Ref: Bear Canyon Mine, INA/015/025, Co-Op Mining Company, Emery  
County, Utah, Hiawatha Seam Drainage

Enclosed are two copies of the revision requested pertaining to  
the Hiawatha Seam Drainage structure which has been installed at  
Bear Canyon Mine.

DRAINAGE CONTROL SYSTEM BEAR CANYON NO. 1 MINE LOWER SEAM PORTAL AREA

FIGURE 7.2-5 Exposed Culvert Anchor

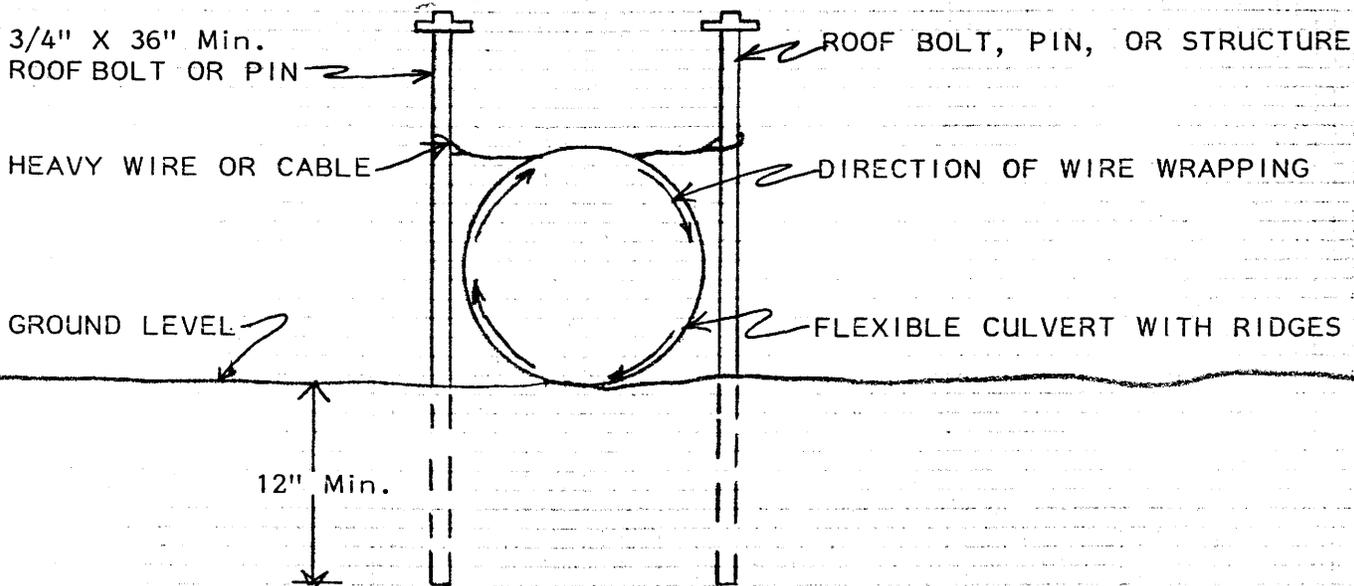
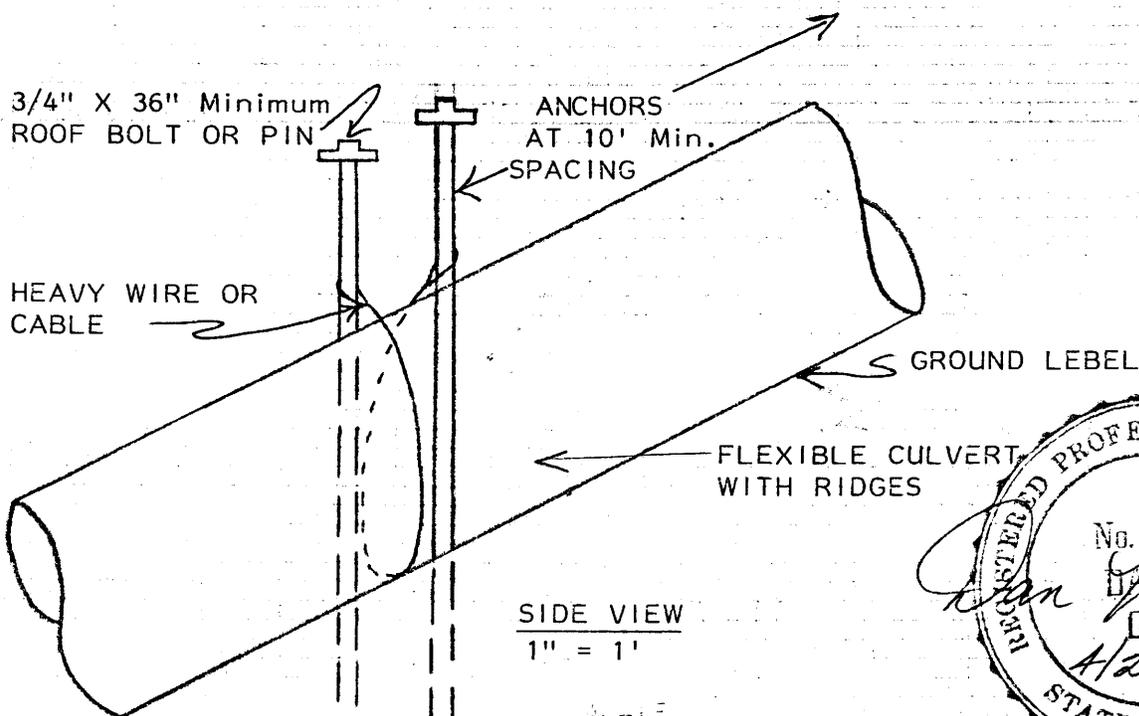
The pad and channel will be constructed prior to placing the flexible culvert in the excavated channel. Where the culvert is on a slope too steep for backfilling to be practical, the culvert will be anchored as shown in Figure 7.2-5. The remaining sections will be backfilled (Figure 7.2-4) and all heavy equipment will be precluded from the area to avoid an accidental crushing of the culvert. The flexible culvert is designed to withstand being buried but will not hold up under heavy equipment traffic.

NOTE: In all areas where the flexible culvert is not buried, it will be anchored per this typical.

FIGURE 7.2-1 Downspout Structure

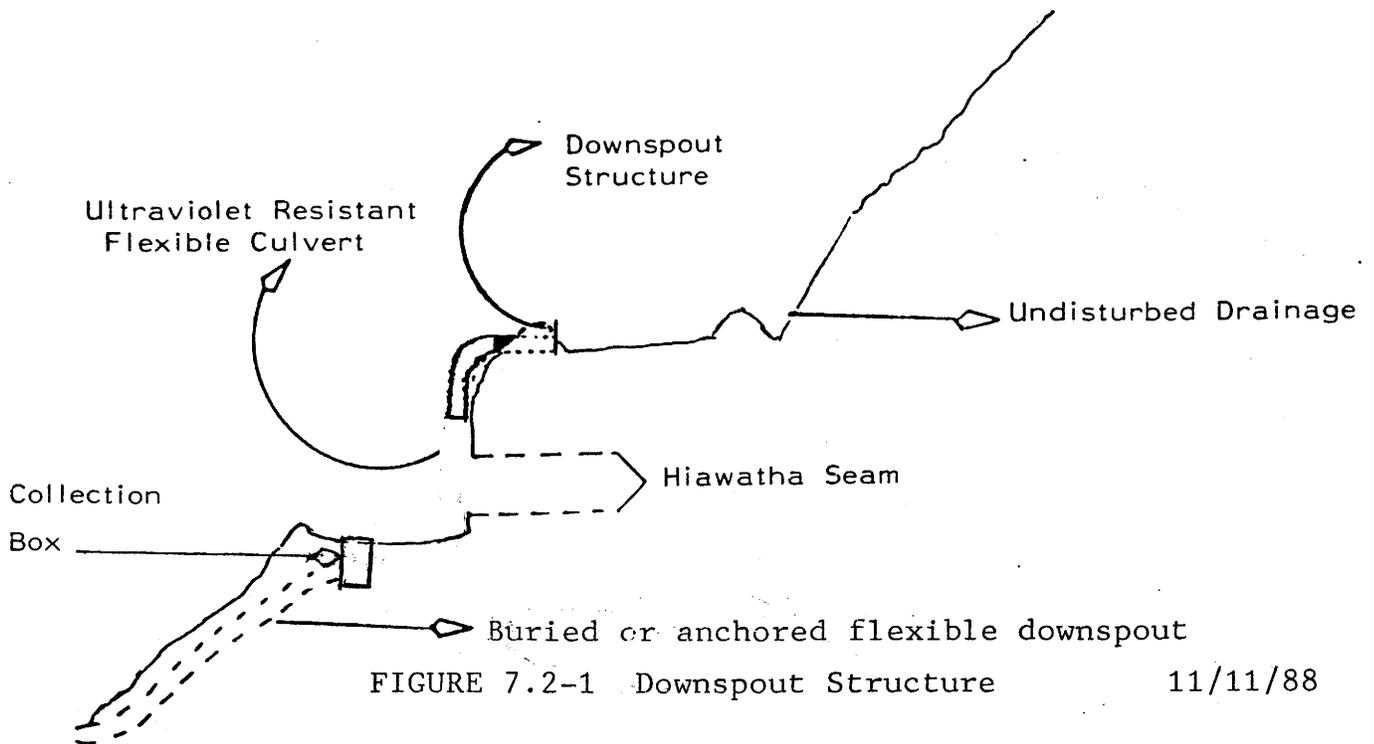
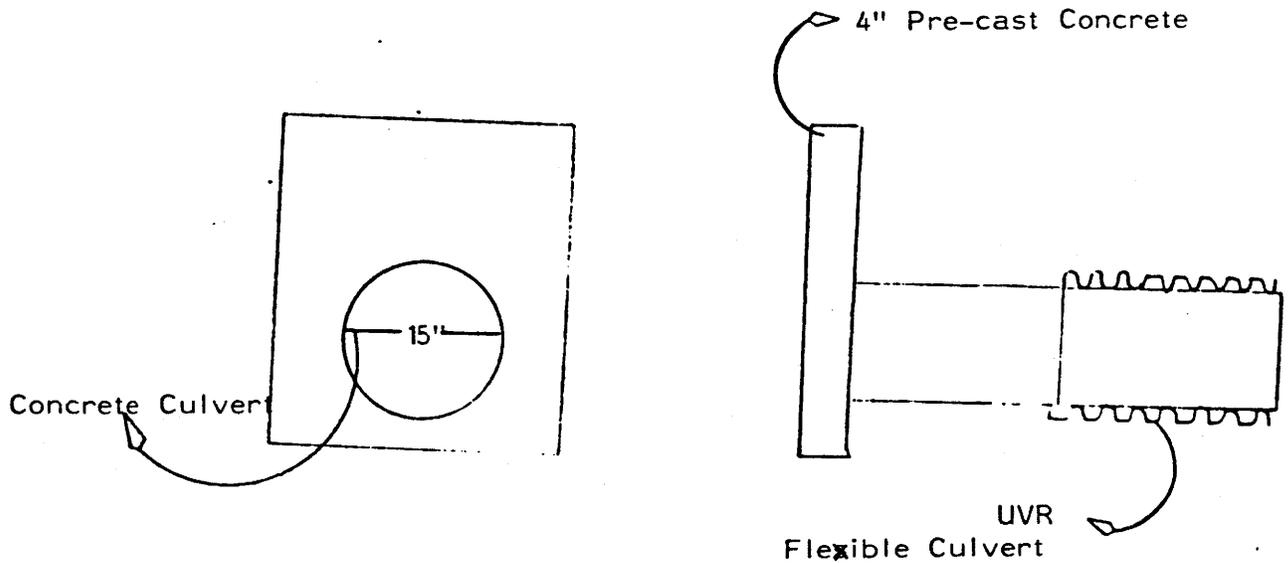
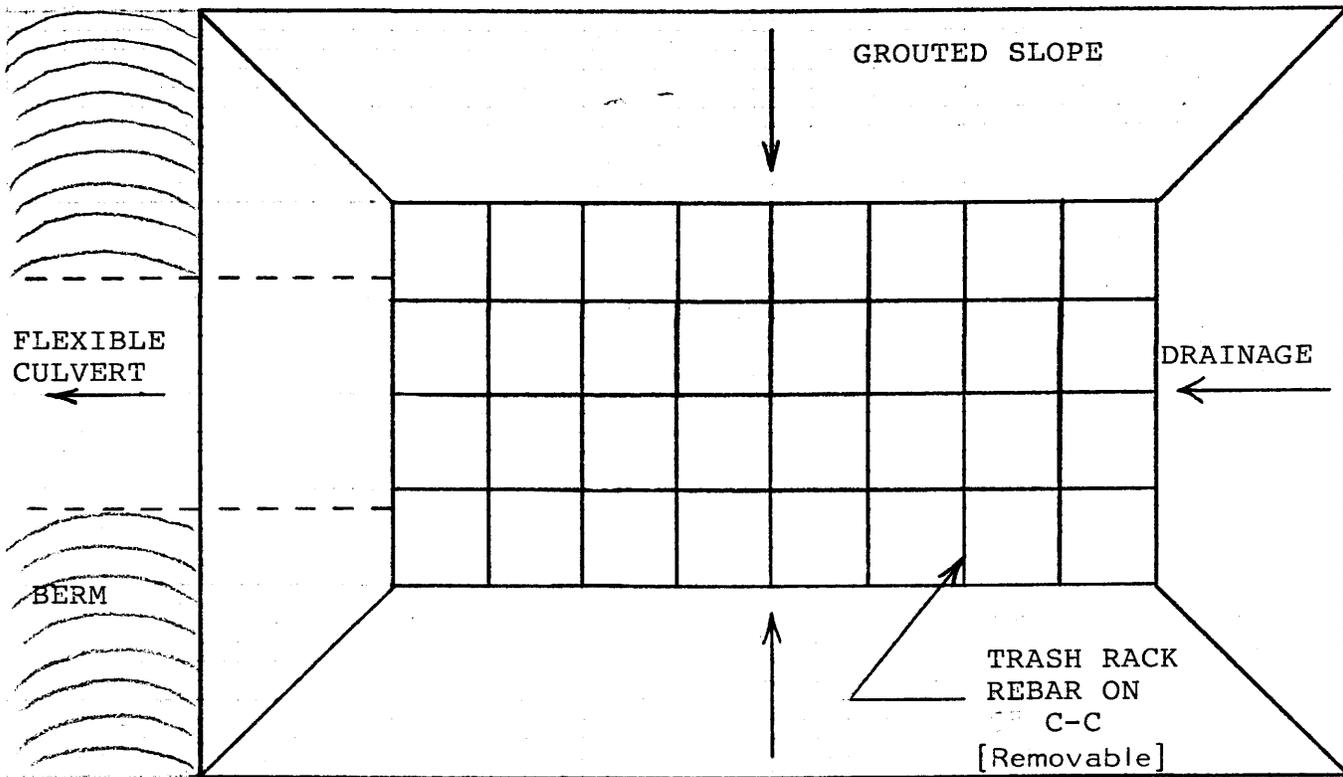
and D-2D. It is proposed to install a 15 in. flexible culvert as shown on Plate 7-1, and Plate 2-2 to convey the drainage from the upper areas of the channel beneath the pad to the coal storage pad below. Installation details are shown in Figures 7.2-1 (Downspout Structure), 7.2-2 (Collection Box), 7.2-3 (Open Culvert Section), 7.2-4 (Buried Cross Sections), 7.2-5 (Exposed Section Anchor) and 7.2-6 (Outlet Protection). Rip-rap specifications will be adhered to as specified.

FIGURE 7.2-2 Collection Box

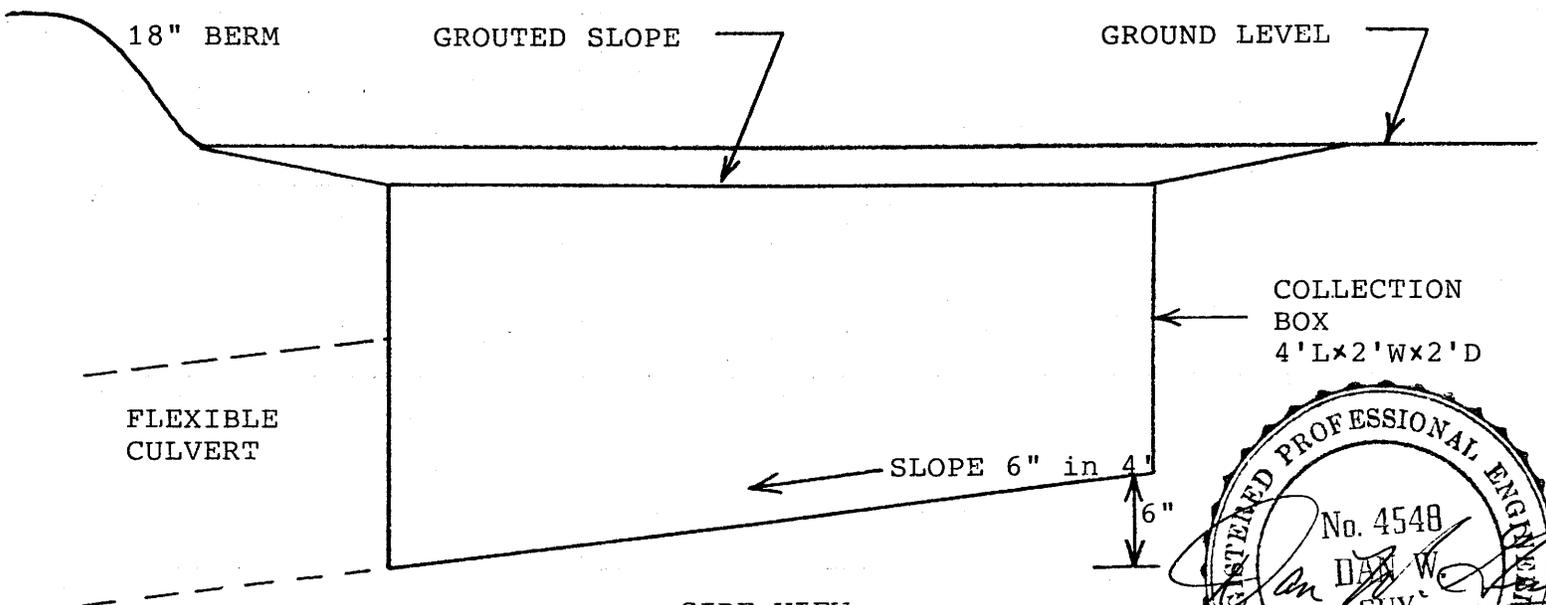
- b. Portal Pad. The northeast corner of the bin will be bermed a minimum of 30 in. high over to the highwall. Runoff water from the upper pad will flow southward around the bin and into a collection box at the edge of the portal pad area; the pad will be sloped to flow to the box;

FIGURE 7.2-3 Open Culvert Typical Section

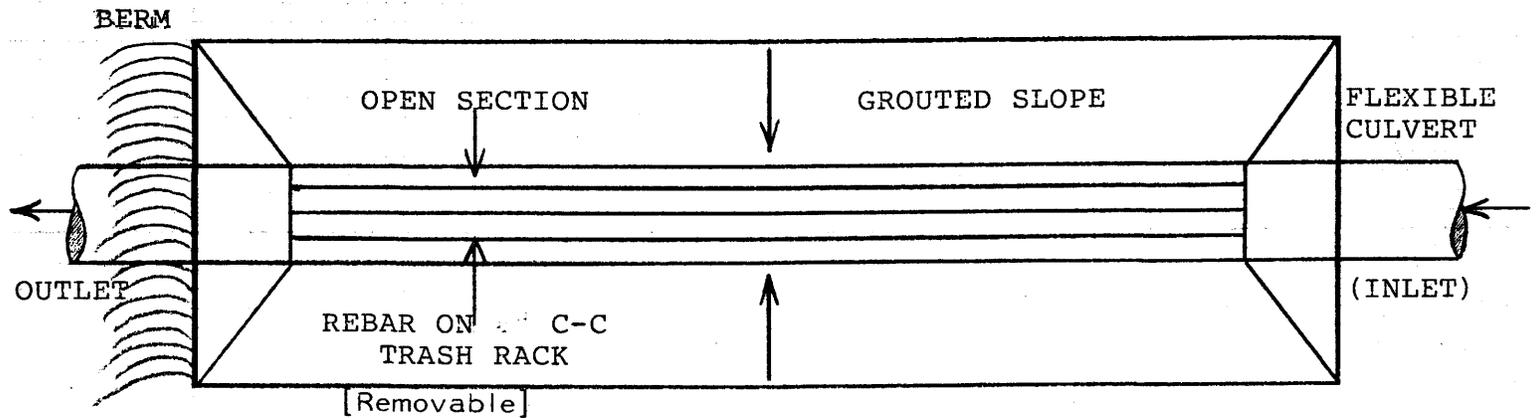
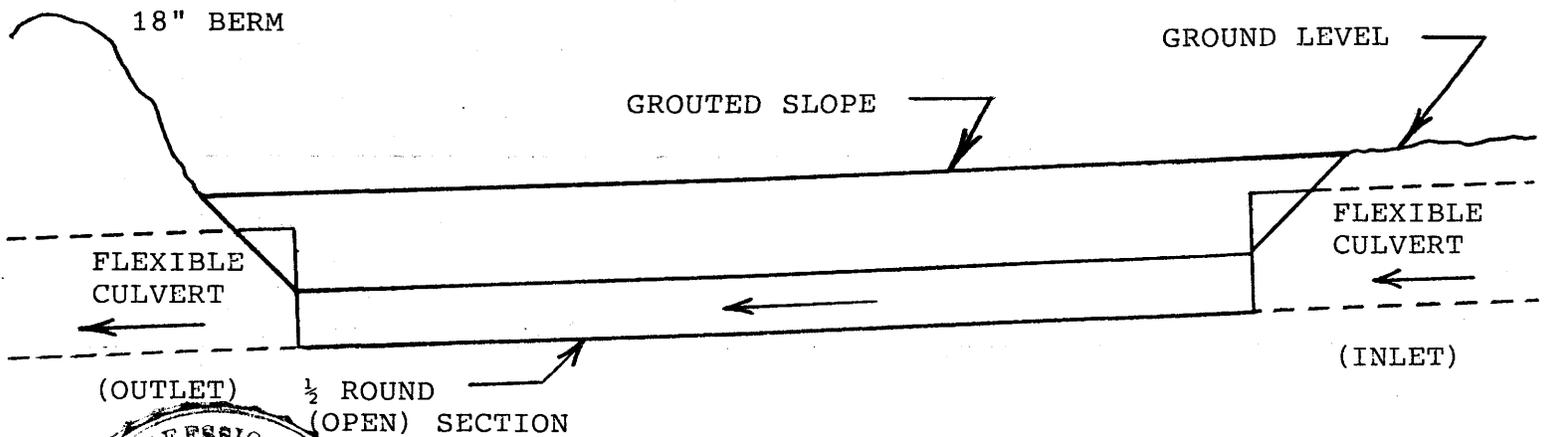
- d. Conveyor Support Pad. This pad will be sloped to drain to the flexible culvert area; the flexible culvert will be opened (or replaced with 1/2 round culvert) for a distance of at least 8 ft to allow surface water to enter the culvert; the entrance to the culvert will be protected by a trash rack and grouted as shown on the attached typical drawing; water will then flow down the flexible culvert to the Coal Processing pad area.

FIGURE 7.2-6 Catch Basin

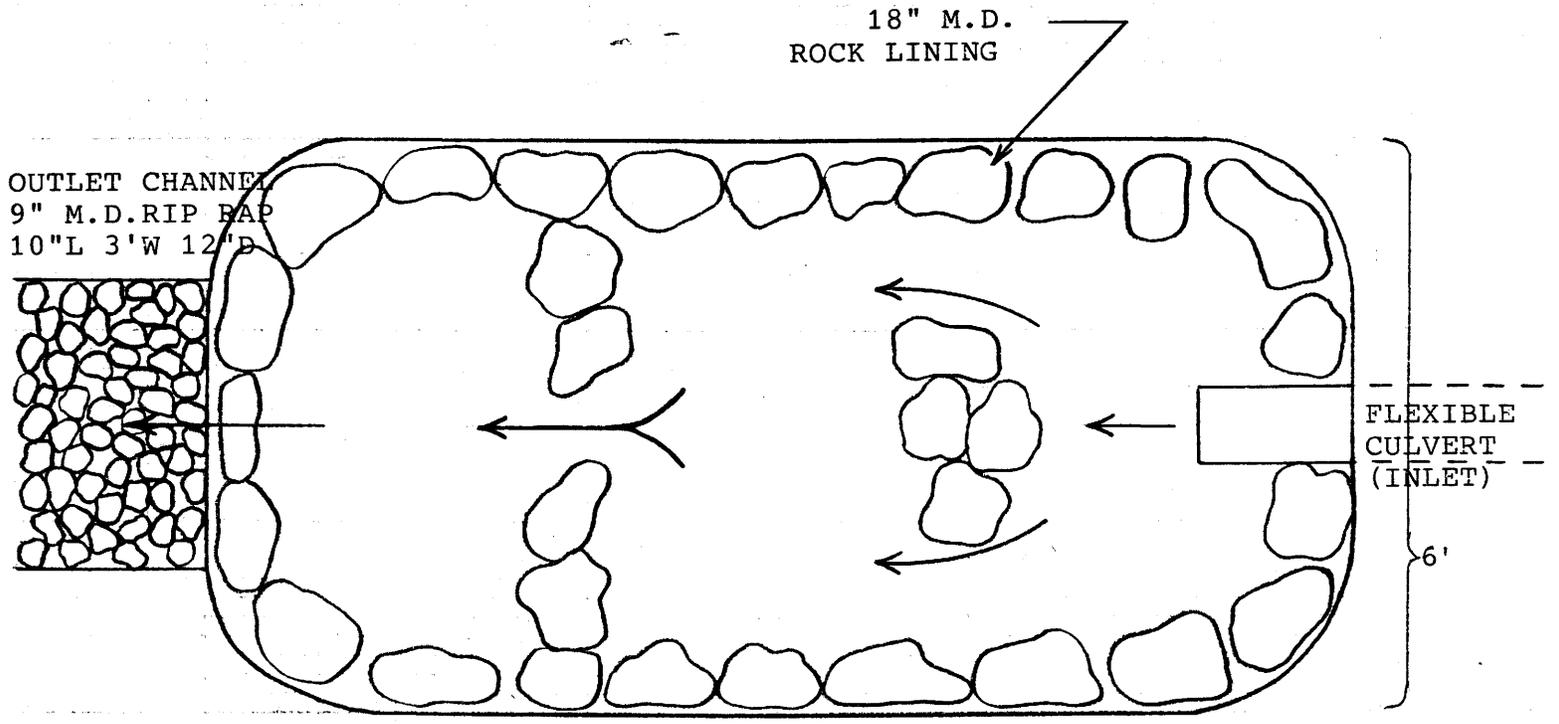
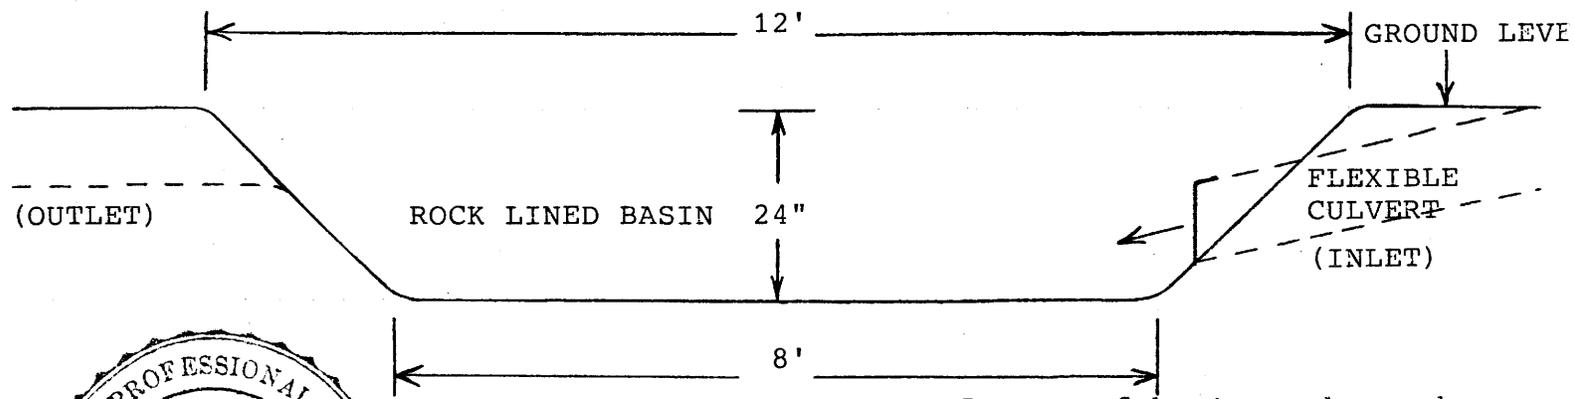
- f. Lump Coal Pad. The flexible culvert will parallel the conveyor down to the lump coal bin, pass beneath the bin supports, and empty into a catch basin/energy dissipater just south of the bin; runoff will then flow south into ditch D-4D and pass through culvert C-2D and onto Sediment Pond "A."

Bottom of basin to be rock lined (18 in. M.D.) if bed-rock is not found during installation.
